Safety Assessment of the HTR Module in Germany cept with

Visit of NRC – Contributions by TÜV Hannover/Sachsen-Anhalt e.V.

Licensing of the German HTR-2 NPP

The Pressure Vessel Unit of the HTR-2 NPP

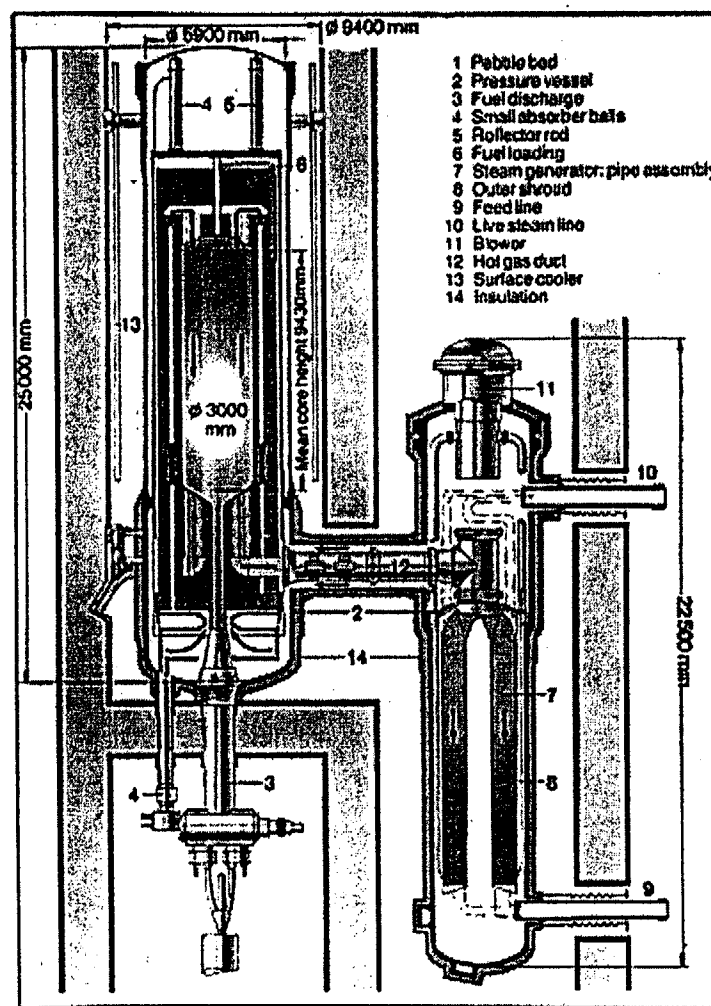
- **Break exclusion confirmed on the basis of fracture-mechanical analyses, but investigation programme and inset probes necessary to determine the neutron-induced embrittlement of the RPV**
- **Main steam nozzle: Mixed welding seam to be shifted from the high-temperature area**
- **Modification of the thermal insulation of the RPV necessary**
- **Filtering concept for medium size ruptures to be modified**
- **Confirmation that the rupture of a large pipe covers the consequences of all postulated ruptures**
- **Fuel design temperature not exceeded**
- **Radiation exposition limits not exceeded**
